**GENOA CHARTER TOWNSHIP
PLANNING COMMISSION PUBLIC HEARING
JUNE 10, 2024
MONDAY
6:30 P.M.
AGENDA**

Attention:	Amy Ruthig, Planning Director
Subject:	Adams Well Drilling – Special Land Use and Site Plan Review #2
Location:	5893 Sterling Drive – north side of Sterling Drive, west of Dorr Road
Zoning:	IND Industrial District

**Re: Adams Well Drilling Parking and Storage Expansion
Site Plan Review No. 2**

Attention:	Amy Ruthig, Planning Director
Subject:	AAA Trailer Sales – Special Land Use and Site Plan Review #2
Location:	4675 Grand River Avenue – north side of Grand River, west of Boulevard Drive
Zoning:	GCD General Commercial District

TITLE: **VEHICLE CIRCULATION PLAN**

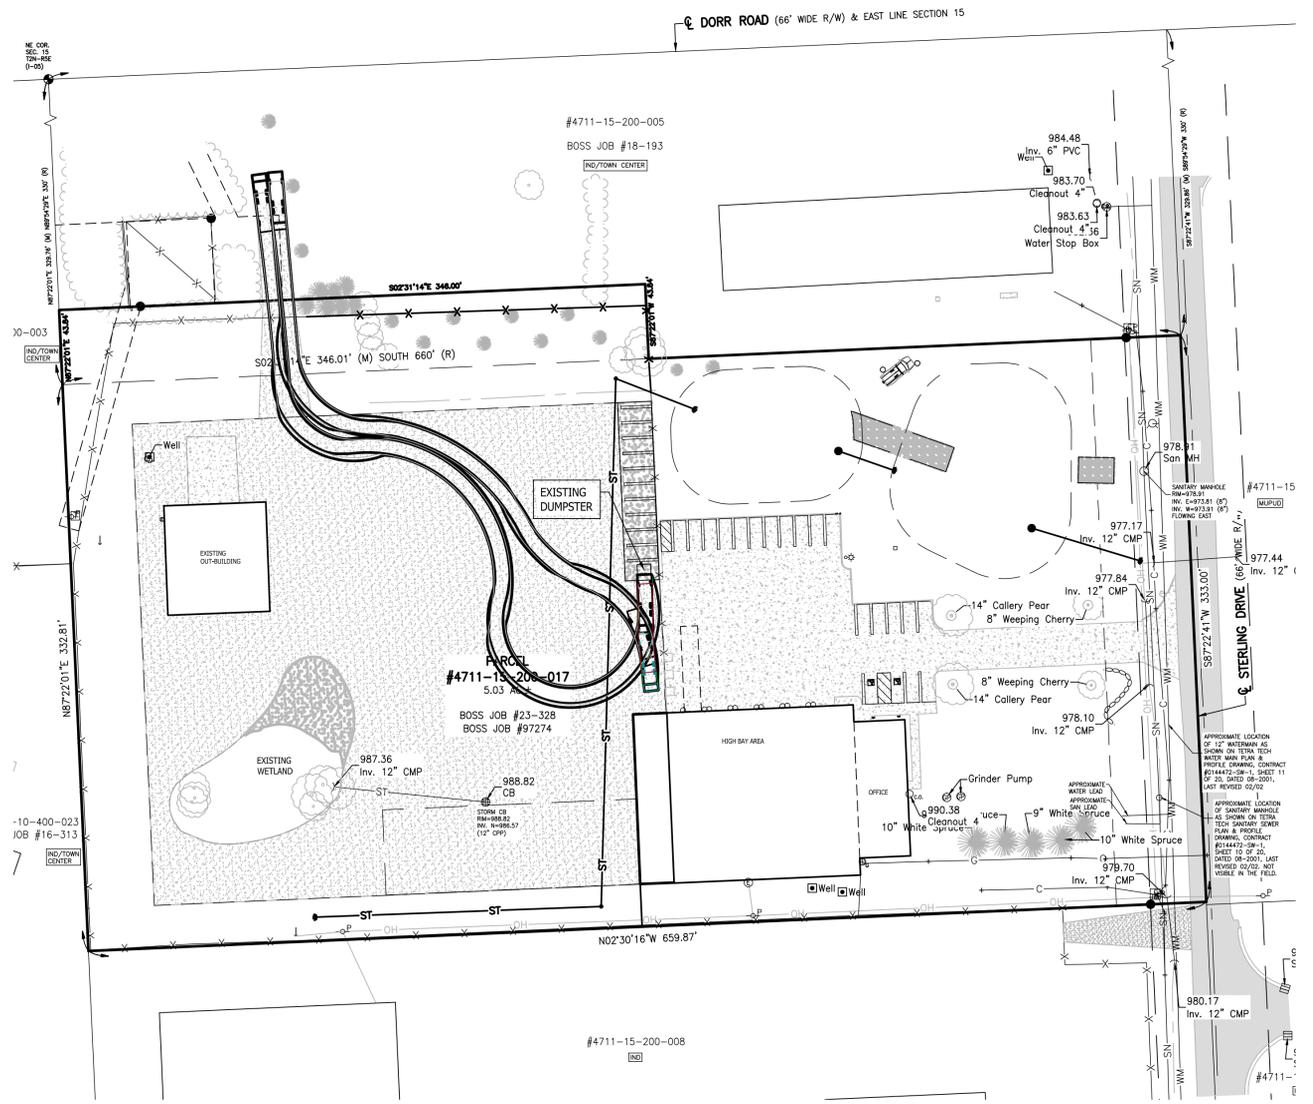
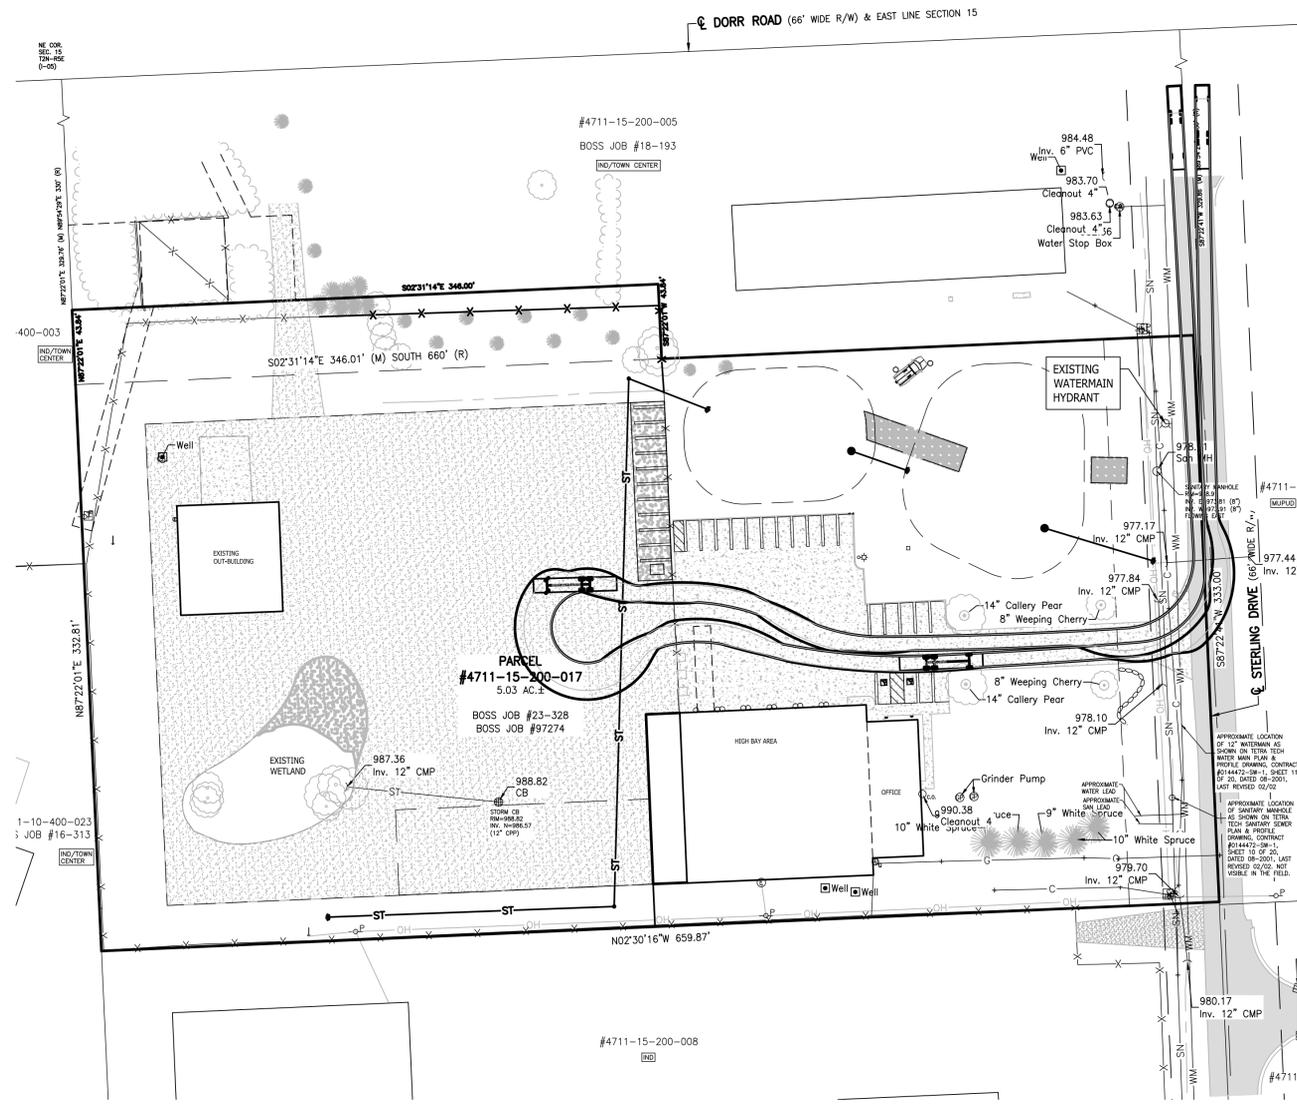
Sheet 8 of the site plan includes a truck turning template, depicting on-site maneuvering between the driveway and outdoor storage area.

TITLE: LANDSCAPE PLAN

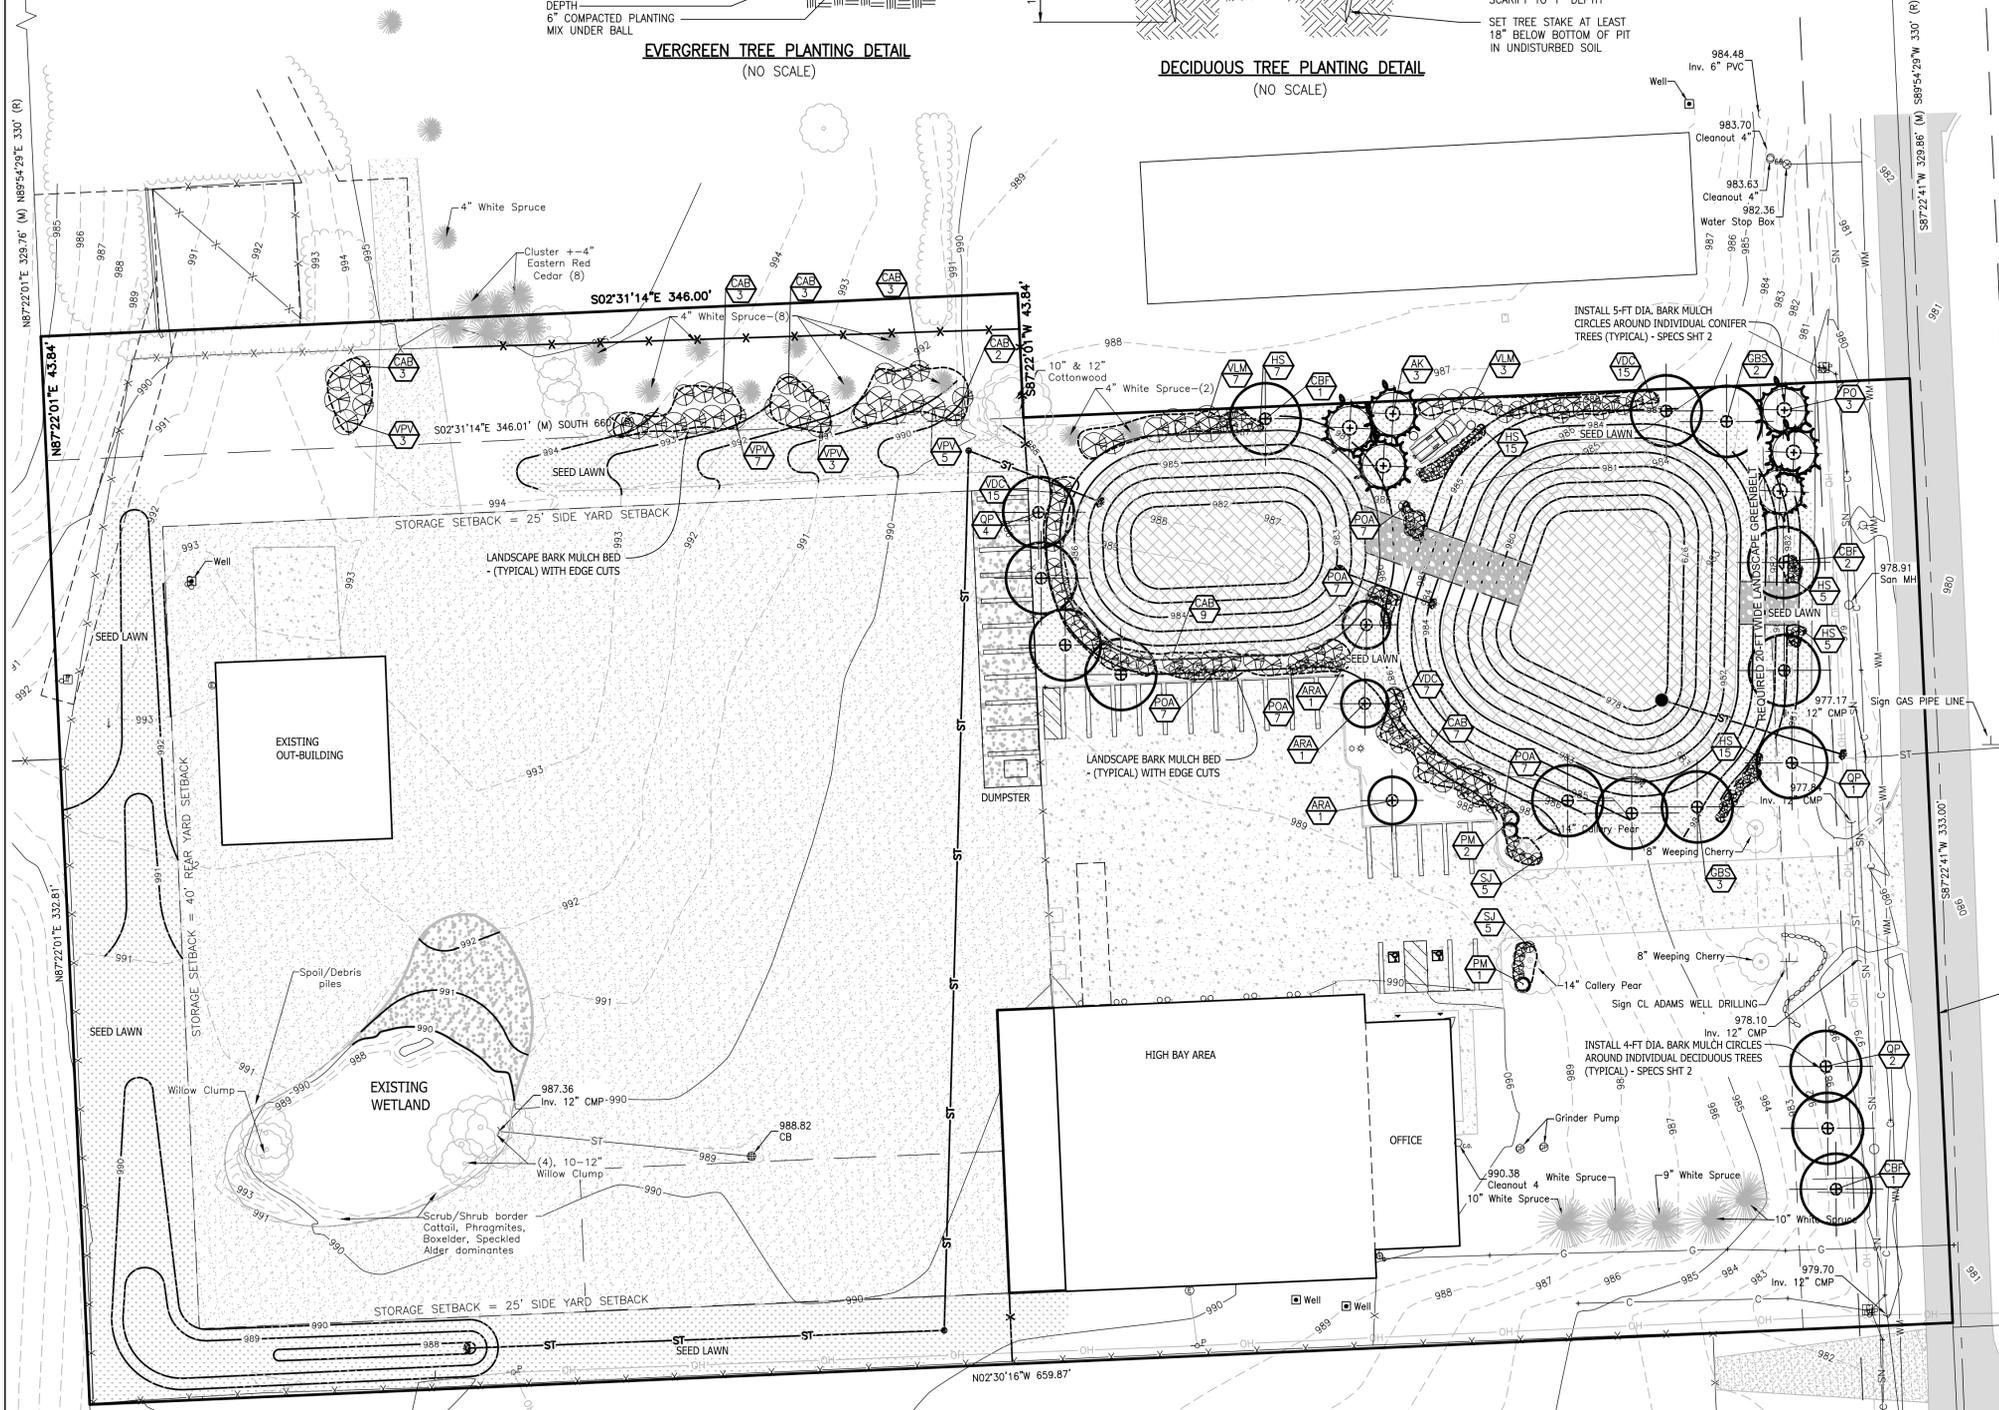
The landscape plan includes new plantings for the front yard greenbelt, around the stormwater ponds and along the east side lot line.

Given the setbacks provided, the required width for a buffer zone B is provided; however, the planting requirements are not fully met.

There is a minor discrepancy between the plan and list with respect to the number of Ivory Halo Dogwood (33 plan; 30 list) and Mariesi Doublefile Viburnum (15 plan; 18 list).

**TRAILER OUTDOOR DISPLAY
SALES AREA PLAN**

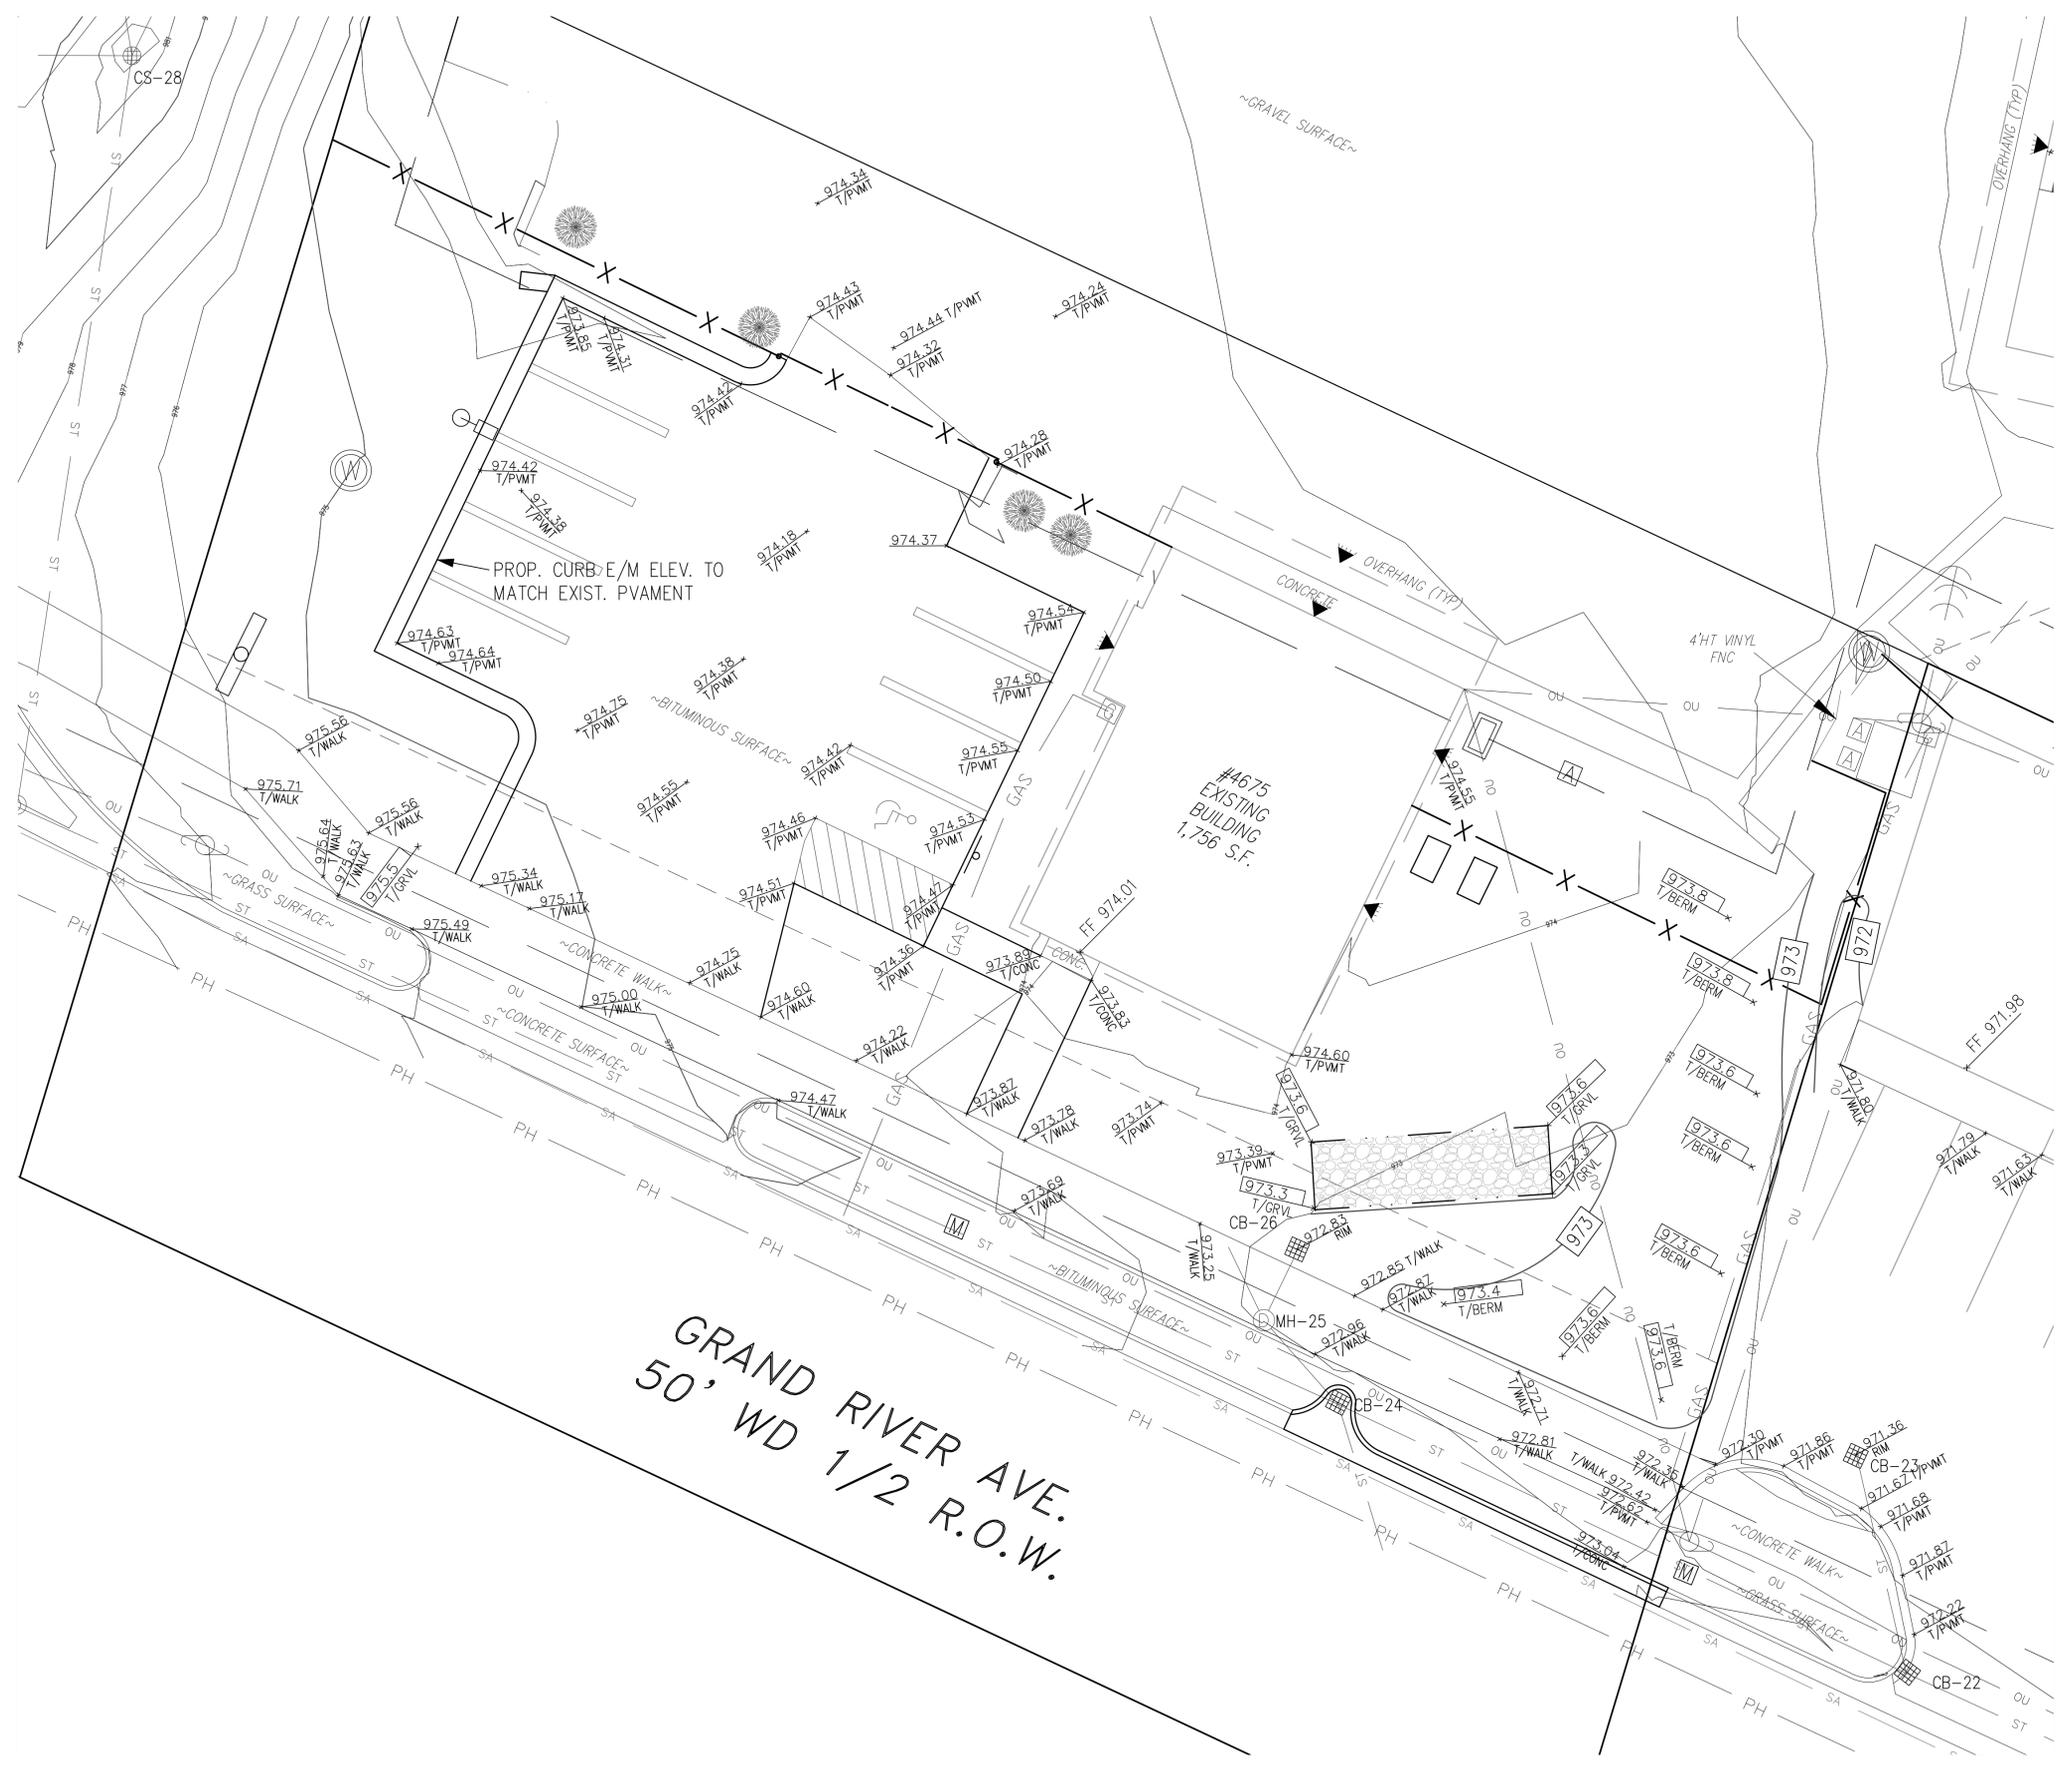
In response to our initial review letter, the applicant has removed several trailers that previously encroached into the Boulevard Drive front yard and 20-foot buffer zone, as well as a display pod in the Grand River front yard.

The revised plan depicts 1 trailer display pod in the Grand River greenbelt. The display pod is in a lawn area with trees and shrubs surrounding.

The buffer zone standards are not fully met, though there is some existing vegetation on site and on the adjacent properties. The plan also includes 6' and 8' privacy fencing on the east and south side of the outdoor storage area.
